Service Bulletin

Bulletin No.: PI1357

Subject: Air Bag Light On, Service Air Bag Message Displayed on DIC

Models: 2014-2015 Buick Enclave
2014-2015 Chevrolet Traverse
2014-2015 GMC Acadia

3990285

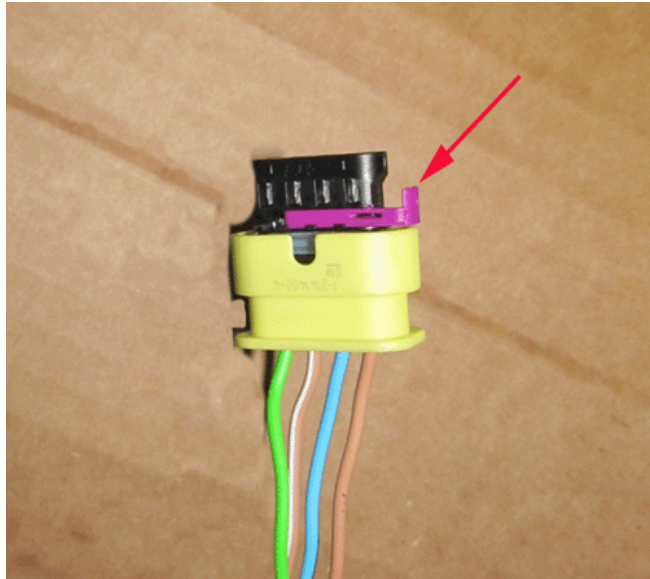
3. Disconnect the connector(s) X333 or X332.
4. Remove 76 mm (3 in) of tape from the body side of the connector to gain access to the wires.

3990716

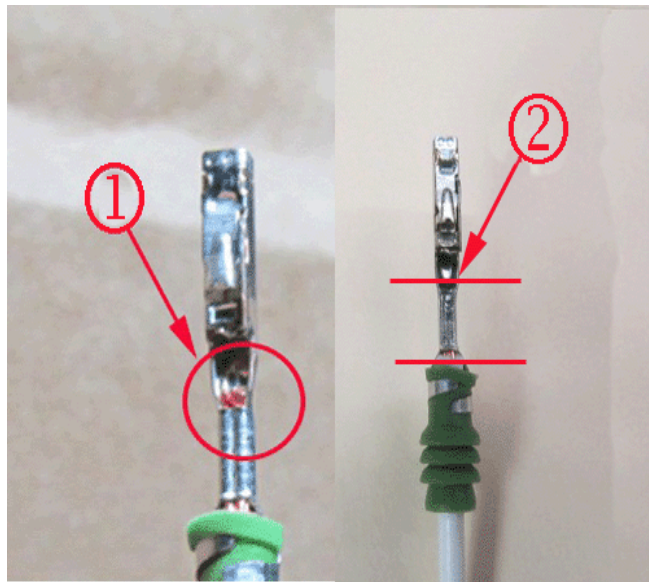
Note: A yellow 4-way connector (passenger) as shown above is similar to the 6-way yellow connector (driver).

5. Remove the terminal position assurance (TPA) lock as shown above.
